U.S. NUCLEAR REGULATORY COMMISSION REGION I  
OPERATOR LICENSING EXAMINATION REPORT

EXAMINATION REPORT NO. 50-057/88-01(OL)  
FACILITY DOCKET NO. 50-057  
FACILITY LICENSE NO. R-77  
LICENSEE: State University of New York at Buffalo  
Rotary Road  
Buffalo, New York 14214  
FACILITY: Buffalo Materials Research Center  
EXAMINATION DATES: February 9 and 10, 1988

1. RO Written Examination and Answer Key
2. Facility Comments on Written Examinations and NRC Resolution

## QUESTION A.01 (2.00)

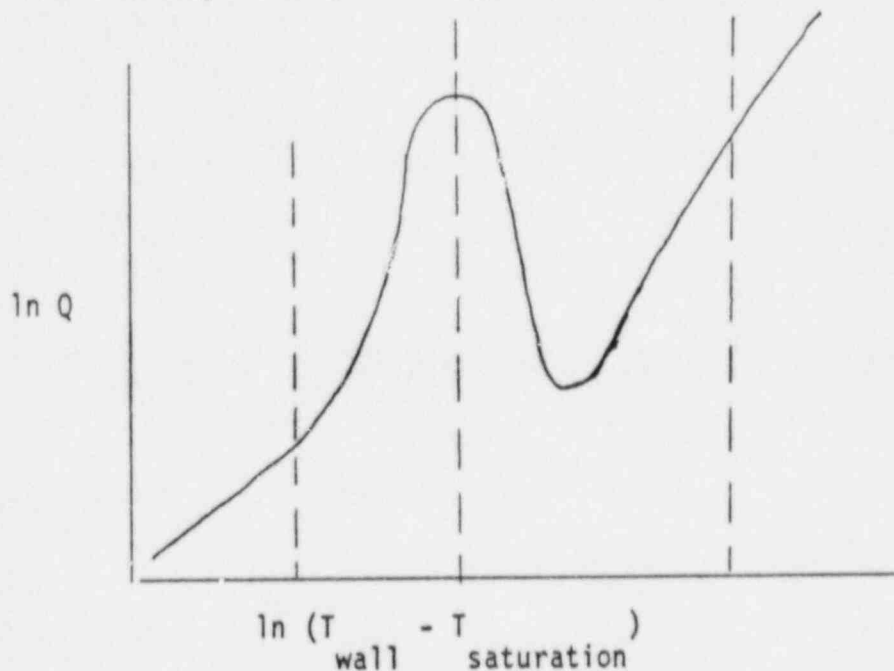
A.01 The answer should reflect the candidates' knowledge rather than require the specific terms given.

RESPONSE: Any adequate definition of the phenomena at hand is acceptable for full credit.

B01

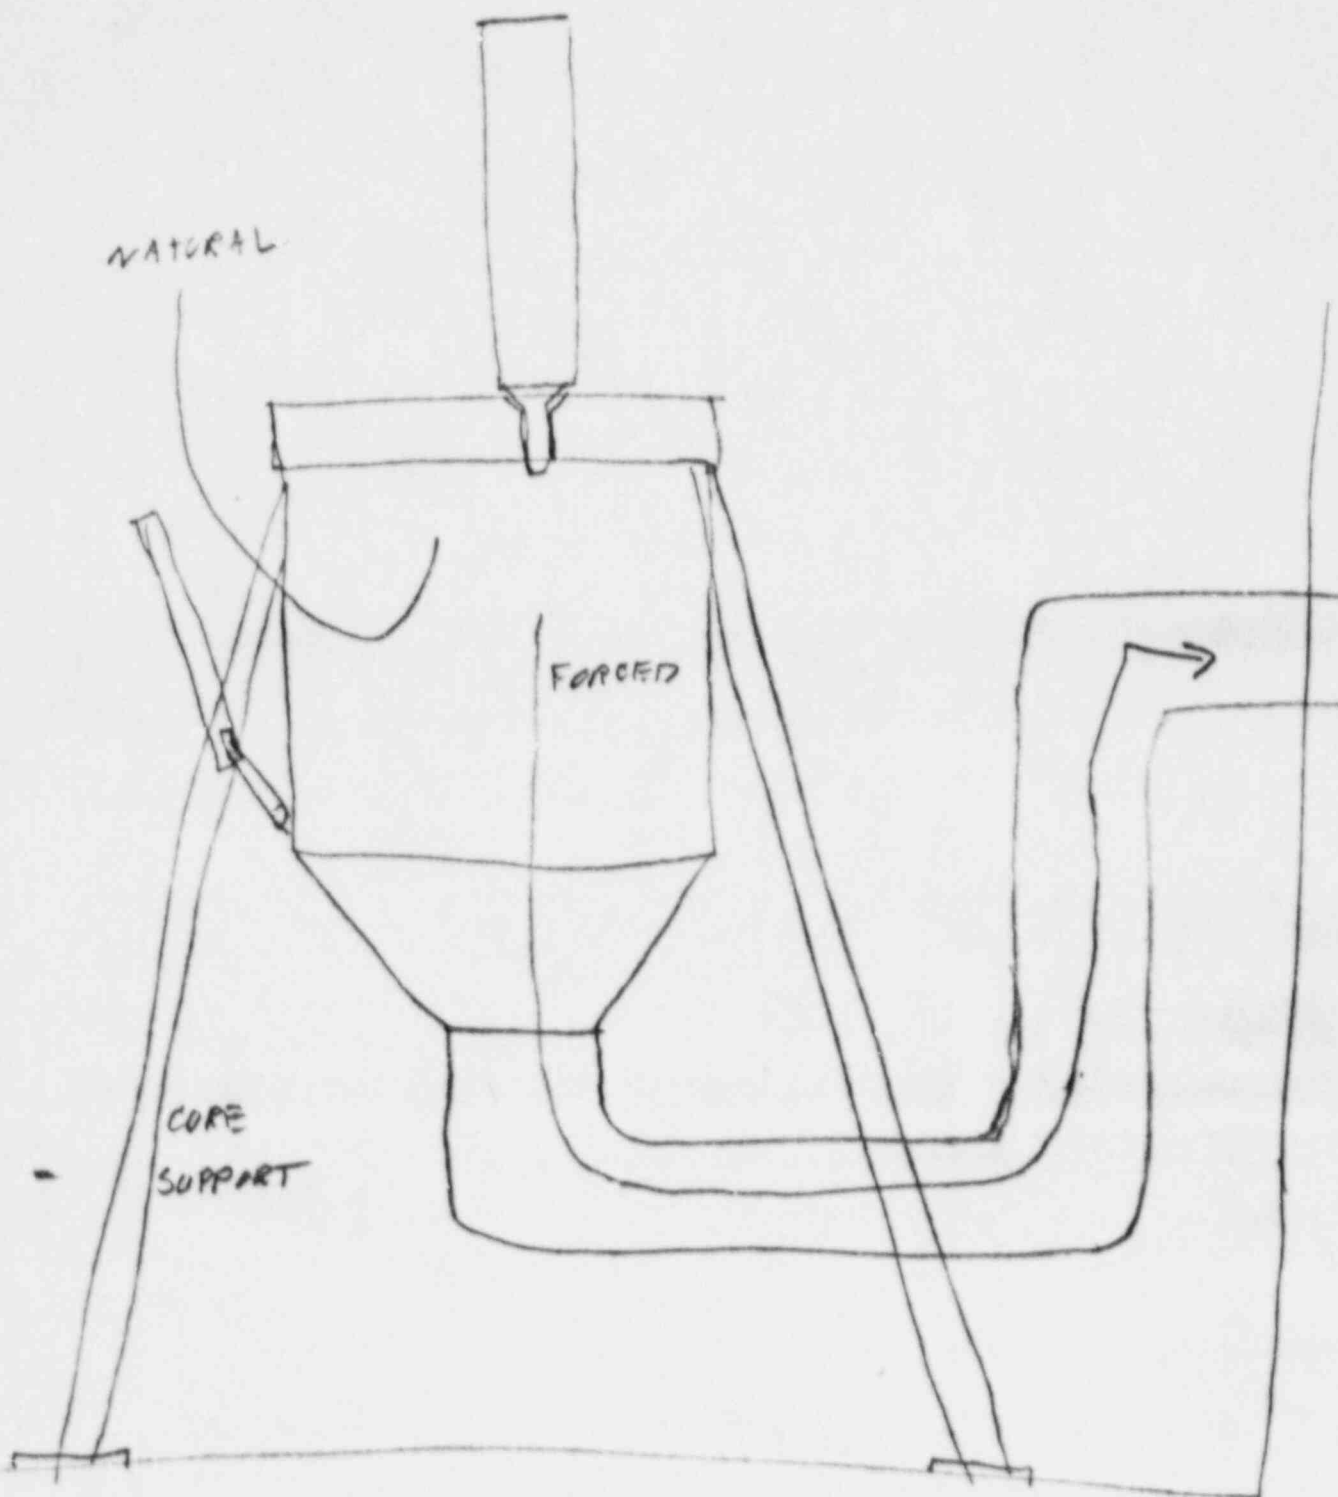
B.01 An improved drawing for the answer key was provided by the facility.

Facility provided drawing  
2/10/88 *DBJ*

ANSWER C.01 (2.50)

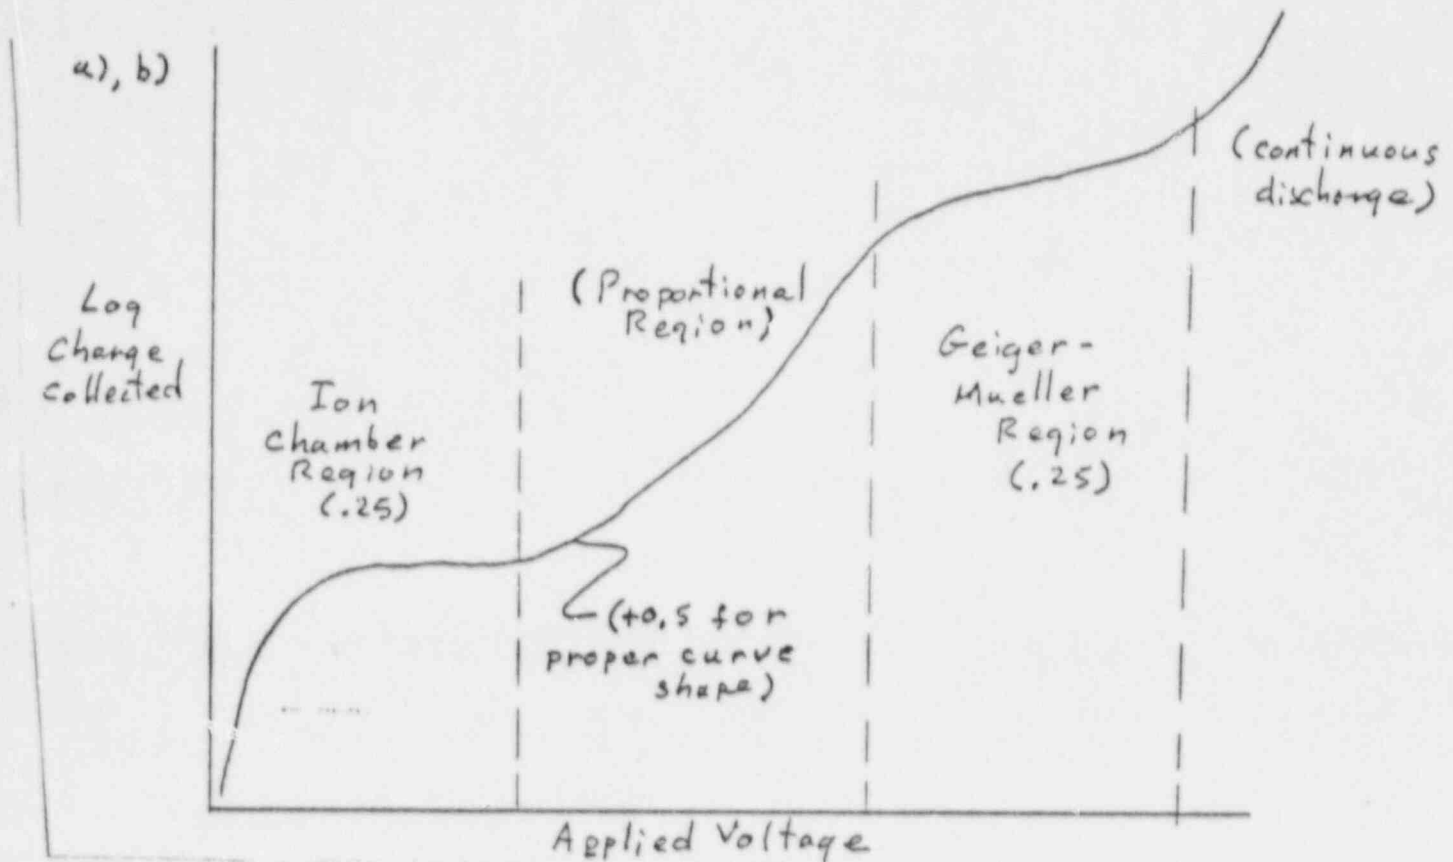
C.01 The question should be restated to "draw the reactivity associated with moderator temperature" rather than draw the moderator temperature reactivity. Additionally, the curve in the answer key is wrong in that the power curve is critically damped, i.e. it does not overshoot in response to step inputs as indicated.

RESPONSE: The semantics are clear as stated, no change in wording is required. Based on your testing data, the curve shape given in the answer key for power and corresponding doppler reactivity were corrected.

ANSWER E.09 (2.00)

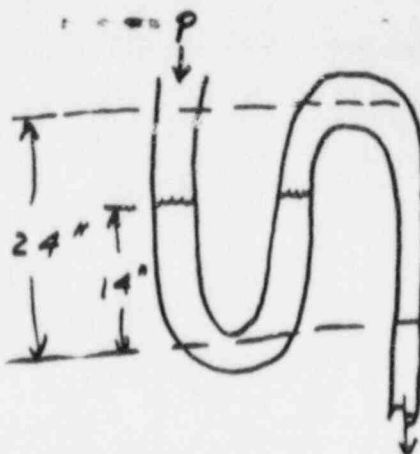
E.09 A 24" loop seal will develop a 24" water column if the equilibrium (static no differential pressure) water height is 12" or greater. The correct answer to this question is 0.87" not the 0.5" indicated on the answer key.

RESPONSE: Accepted. The answer key was changed to reflect the larger water column.
